Appl. No. : 10/630,008
Filed : July 29, 2003

REMARKS

This is in response to the Office Action mailed February 24, 2004. After this amendment, Claims 1-23 are pending in the application.

Fig. 1

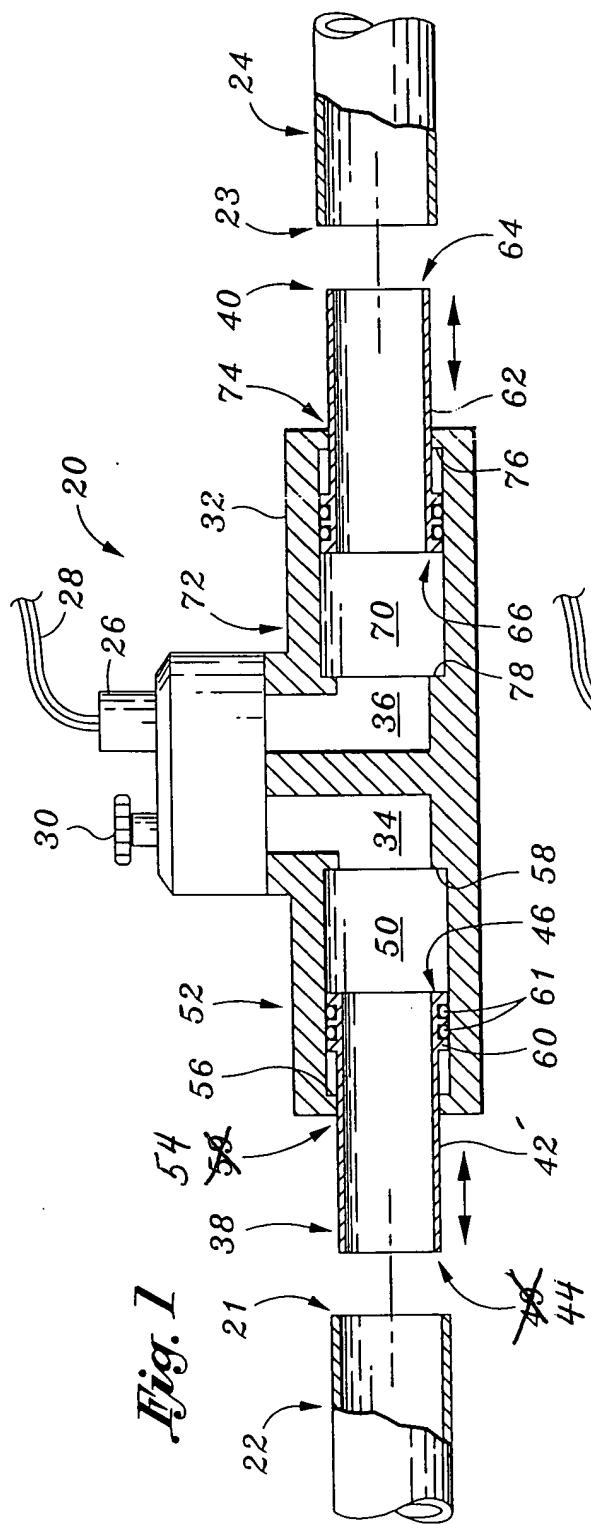
The Examiner objected to the drawings for the reason that reference numeral 54 was missing therefrom and because the designation 44 in Figure 1 should be 49. Applicant has submitted herewith corrected figures (including a set in red-line) which includes these corrections.
